ETS 300 608

A1

**This amendment A1 modifies
the European Telecommunication Standard ETS 300 608 (January 1995)**

**European digital cellular telecommunications system (Phase 2);
Specification of the Subscriber Identity Module -
Mobile Equipment (SIM - ME) interface
(GSM 11.11)**

Figure 7: File identifiers and directory structures of GSM

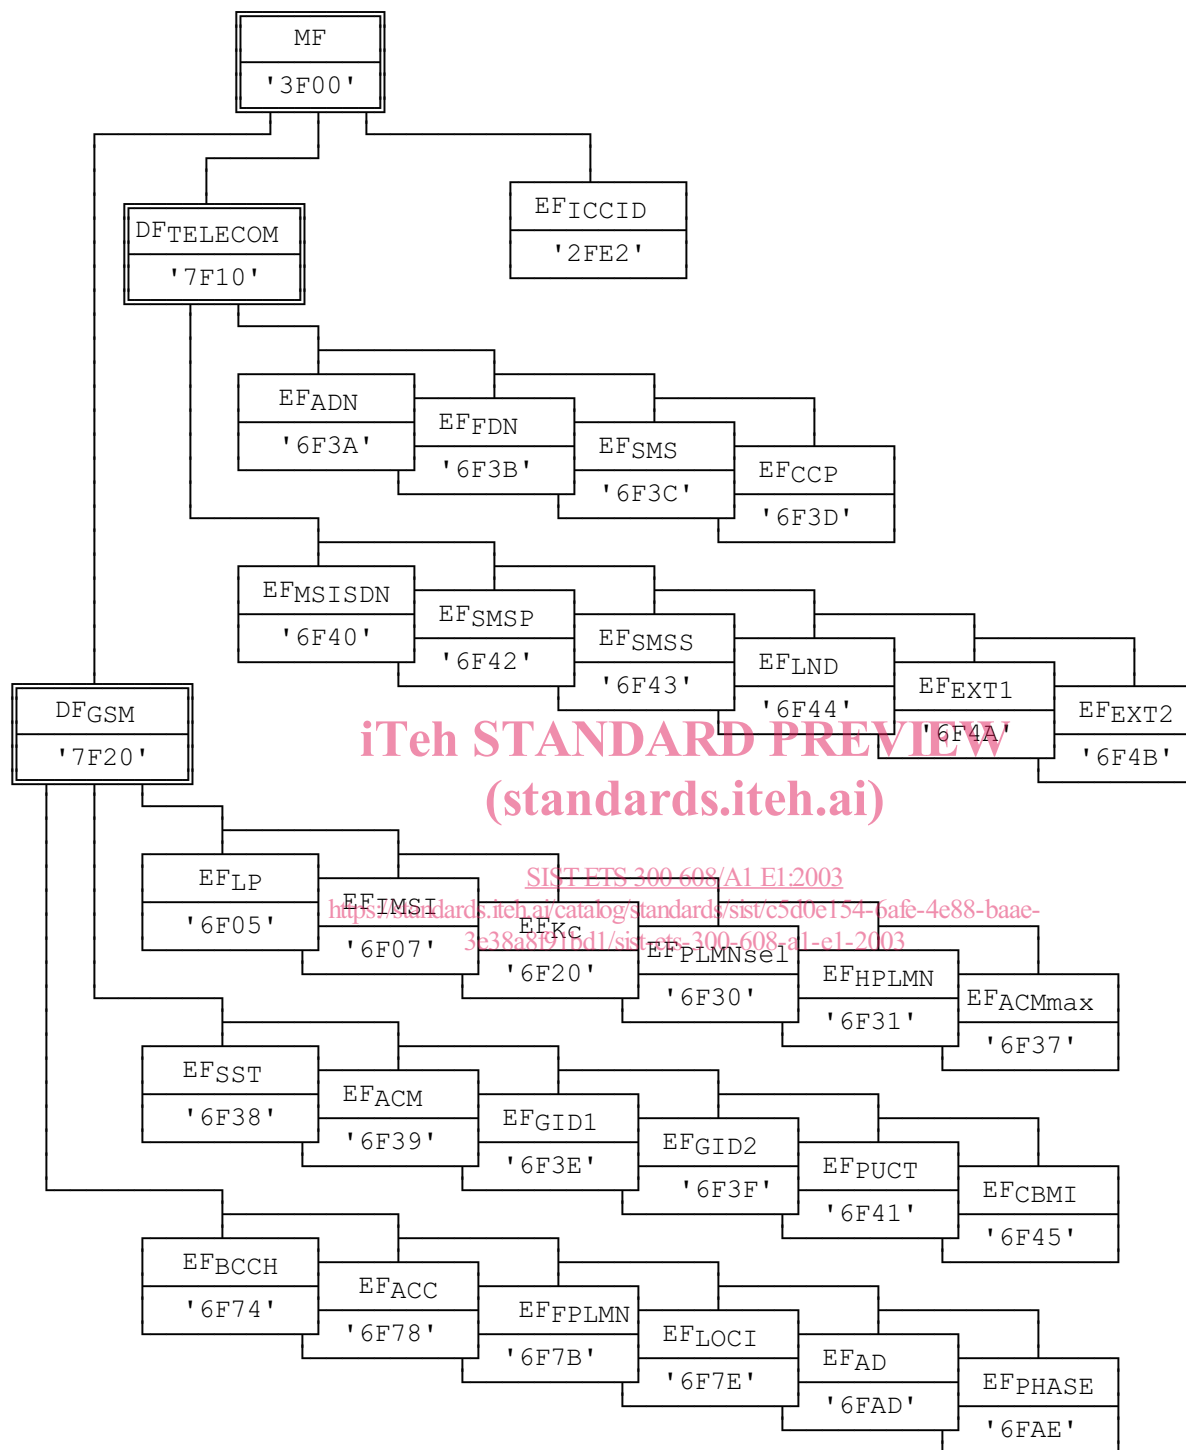
Page 74, subclause 10.4.

Replace the existing figure 7 with the following new figure 7:
